APPEAL SUMMARY

Appeal ID: 27588	Project Address: 701 NE Burnside St
Hearing Date: 3/16/22	Appellant Name: Tom Jaleski
Case No.: B-009	Appellant Phone: 971.238.5266
Appeal Type: Building	Plans Examiner/Inspector: Corey Stanley
Project Type: commercial	Stories: 4 Occupancy: R-2, B, M Construction Type: V-A
Building/Business Name:	Fire Sprinklers: Yes - throughout
Appeal Involves: Reconsideration of appeal	LUR or Permit Application No.:
Plan Submitted Option: pdf [File 1] [File 2] [File 3] [File 4] [File 5] Proposed use: Residential

APPEAL INFORMATION SHEET

Figure 1: Detail Section at Beam Typical

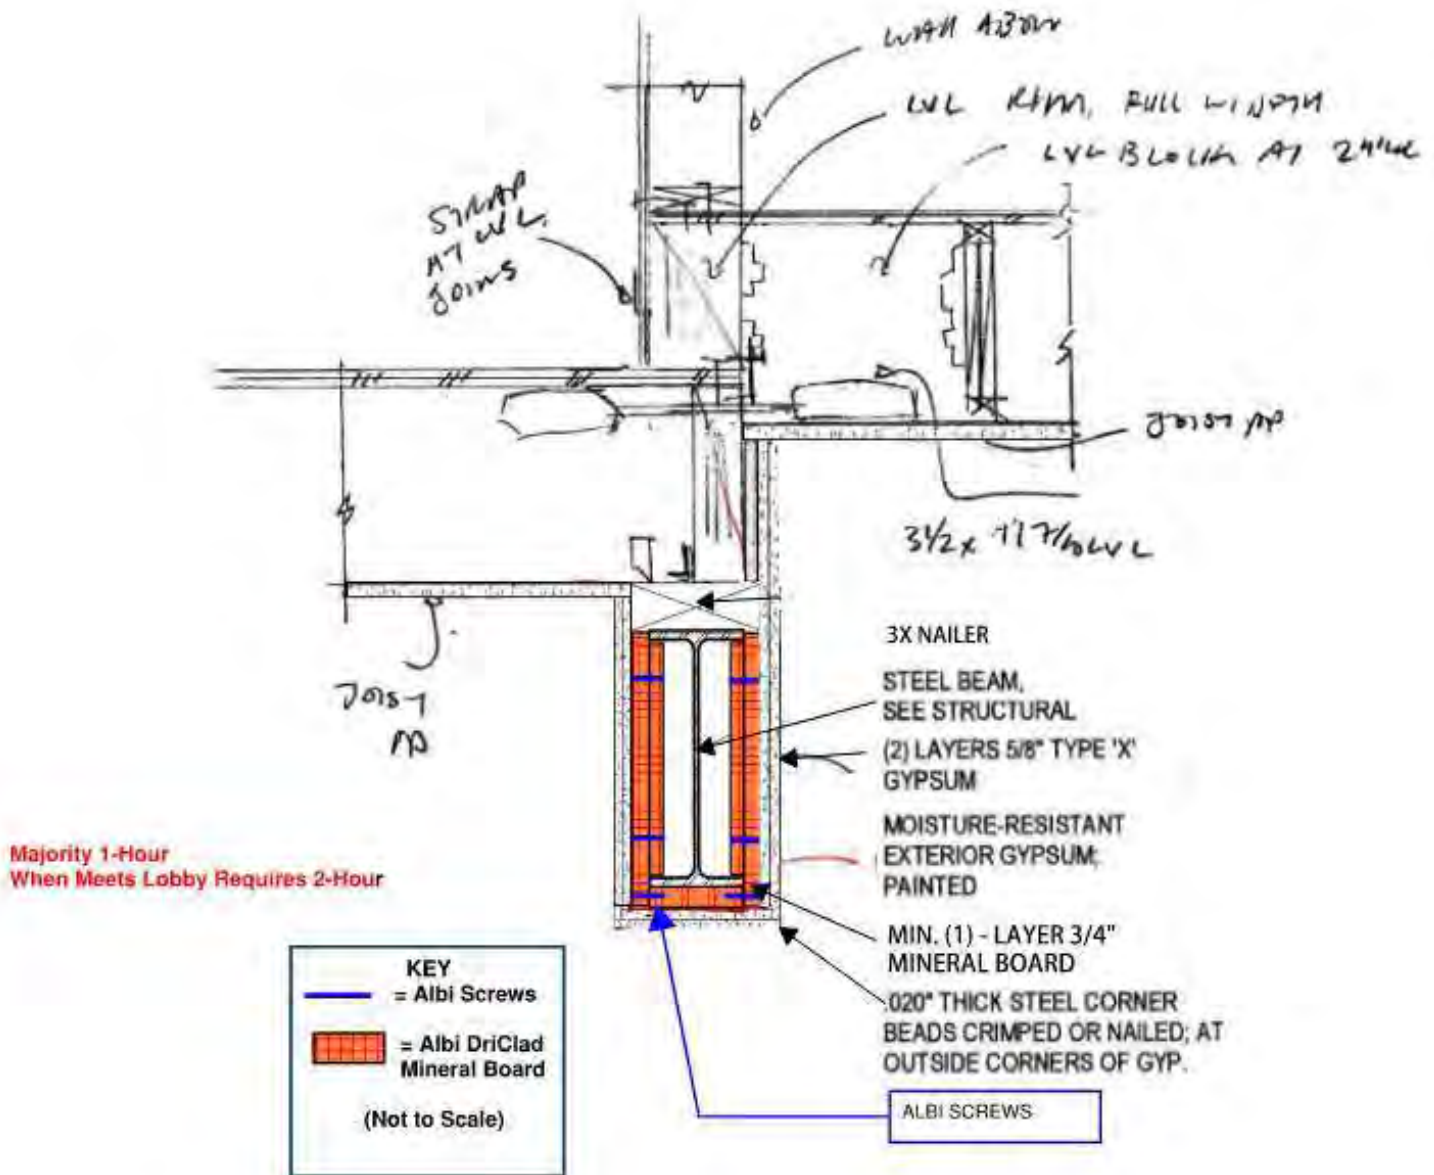
The proposed assemblies consist of a beam supporting a 2-Hour rated floor assembly above. The encasement of the beam includes two layers of Type "X" Gypsum and a minimum of one (1) layer of 3/4" mineral wool board around the three exposed sides of the beam; additionally two (2) layers of 5/8" Type "X" gypsum are proposed to entirely cover the mineral board and encase the assembly as displayed in Figure 1. Figure 2, within attached EJ#1, has a special condition approved for the Lobby that requires to have a 2-hour floor-ceiling envelope, also requiring the beam passing thru this space to be 2-hour individually encased and protected as well. See Figure 3 in EJ for Architectural Detail #15, the 2-hour rated floor/ceiling assembly.

The proposed assemblies consist of a beam supporting a 2-Hour rated floor assembly above. The encasement of the beam includes two layers of Type “X” Gypsum and a minimum of one (1) layer of 3/4” mineral wool board around the three exposed sides of the beam; additionally two (2) layers of 5/8” Type “X” gypsum are proposed to entirely cover the mineral board and encase the assembly as displayed in Figure 1. Figure 2 has a special condition approved for the Lobby that requires to have a 2-hour floor-ceiling envelope, also requiring the beam passing thru this space to be 2-hour individually encased and protected as well. See Figure 3 for Architectural Detail #15, the 2-hour rated floor/ceiling assembly.

1. Alternate 2 hour fire rated beam assembly with engineering analysis: Granted as proposed.

Figure 1: Proposed Assembly Recess At Plaza Exterior Wall

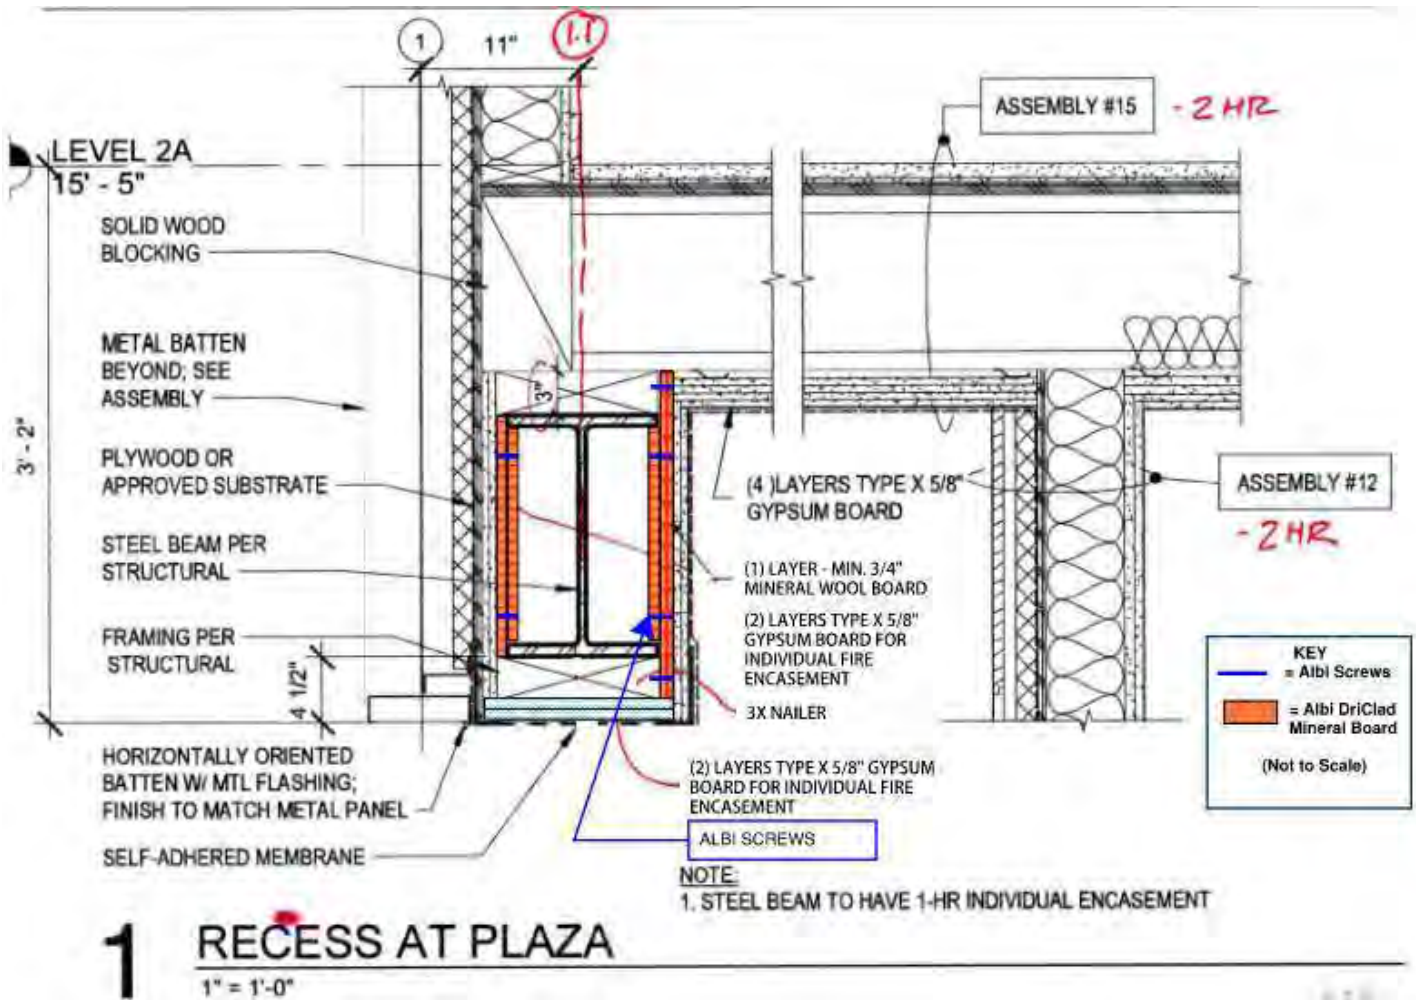
Proposed Design	<p>The proposed assembly consists of a beam supporting a 2-Hour rated floor assembly above. The encasement of the beam includes two layers of Type "X" Gypsum and a minimum of one (1) layer of 3/4" mineral wool board around the three exposed sides; additionally two (2) layers of 5/8 Type "X" are proposed to entirely cover the mineral board and encase the assembly as displayed in Figures 1 in EJ #2. See Figure 2 for the location of the proposed beam assembly. Please see the attached EJ #2.</p> <p>RECONSIDERATION TEXT:</p> <p>The proposed assembly consists of a beam supporting a 2-Hour rated floor assembly above. The encasement of the beam includes one (1) layer of 3/4" mineral wool board around the three exposed sides.</p> <p>Installation of one (1) layer of 3/4" Albi DriClad Mineral Fiber Board through UL design S301. The mineral boards shall be installed with strips a min 4 inches wide, every 2 feet within beam span, friction fit, material is then cut to box in the steel beam assembly with 1 inch overhang, noggins along the bottom flanges friction fit, Albi Screws a min 2.25 inch 6 inch OC fasten the mineral boards to maintain independence of the assembly UL S301.</p> <p>In addition the project proposes to encase UL Design S301 with two (2) layers of 5/8" Types "X" gypsum wallboard, installed per UL Design N501 to exceed the minimum 2-hour fire-resistance rating as detailed in EJ #2. Through the protection provided by Albi DriClad Mineral Fiber Board in addition to 2 layers 5/8" Type "X" gypsum wall board UL No. S301. The Mineral Board will be used in lieu of the steel beam cage in UL No. N501.</p> <p>The Albi DriClad will be self-supporting and structurally independent per UL Design S301 such that the loss of gypsum wall board during a fire incident should not impact the Albi DriClad and therefore the fire-resistance rating of the beam assembly. Please see the attached EJ #2.</p>

The proposed assembly consists of a beam supporting a 2-Hour rated floor assembly above. The encasement of the beam includes two layers of Type "X" Gypsum and a minimum of one (1) layer of 3/4" mineral wool board around the three exposed sides; additionally two (2) layers of 5/8" Type "X" are proposed to entirely cover the mineral board and encase the assembly as displayed in Figures 1. See Figure 2 for the location of the proposed beam assembly.

2. Alternate 2 hour fire rated beam assembly with engineering analysis: Granted as proposed.

Figure 1: Proposed Assembly at 1A Detail Typical 1-Hour

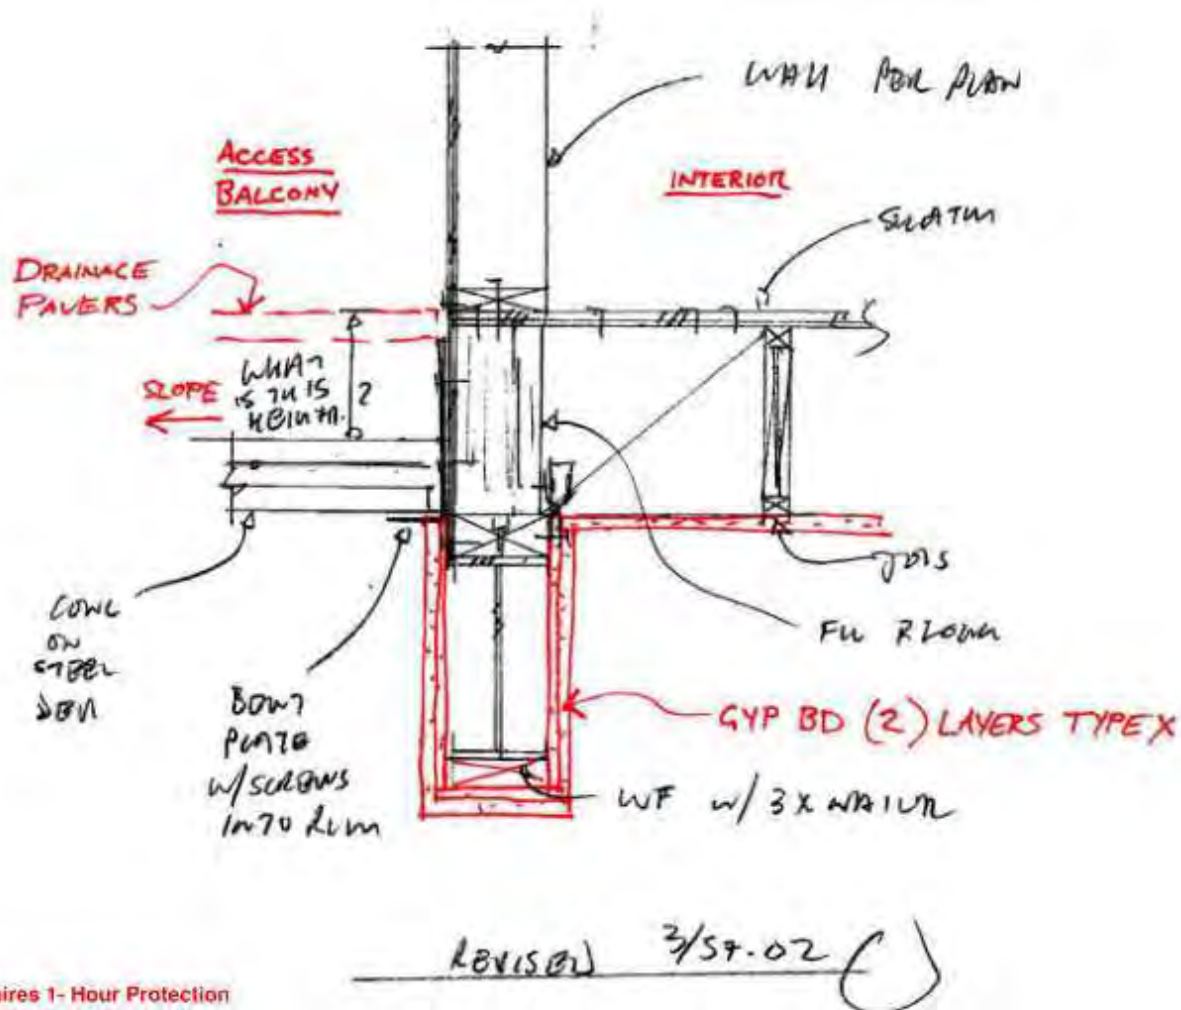
The proposed beam assembly consists of a 3x wood nailer from above, two (2) layers of 5/8 Type "X" to entirely encase the beam from each side, a 3x nailer below (that can be optional as it does not provide required fire protection to the encasement) and two (2)) layers of 5/8 Type "X" from below as displayed in Figure 1 within attached EJ #3.

The proposed beam assembly consists of a 3x wood nailer from above, a 3x nailer below (that can be optional as it does not provide required fire protection to the encasement) with two (2) layers of 5/8 Type "X" gypsum wallboard to be installed around beam, Base Layer attached with 1-1/4" Type S screws 16" OC. Face layer attached with 1-3/4" Type S screws 8" OC to entirely encase the beam from each side and two (2) layers of 5/8 Type "X" gypsum, Base Layer attached with 1-1/4" Type S screws 16" OC. Face layer attached with 1-3/4" Type S screws 8" OC to from below as displayed in Figure 1 within attached EJ #3.

The proposed beam assembly consists of a 3x wood nailer from above, two (2) layers of 5/8” Type “X” to entirely encase the beam from each side, a 3x nailer below (that can be optional as it does not provide required fire protection to the encasement) and two (2)) layers of 5/8” Type “X” from below as displayed in Figure 1 below.

The proposed steel beam assembly at grid line 5, Level 2B at the balcony is required to meet a 1-Hour fire-resistance rating per 2019 OSSC. It is assumed that the beam could be exposed to fire and the assembly will require continuous protection from all exposed sides. Per §704.3 requires individual encasement to provide protection for all fire exposed sides of the beam assembly to meet or exceed the required 1-hour fire-resistance rating.

3. Alternate 1 hour fire rated beam assembly with engineering analysis: Granted as proposed.
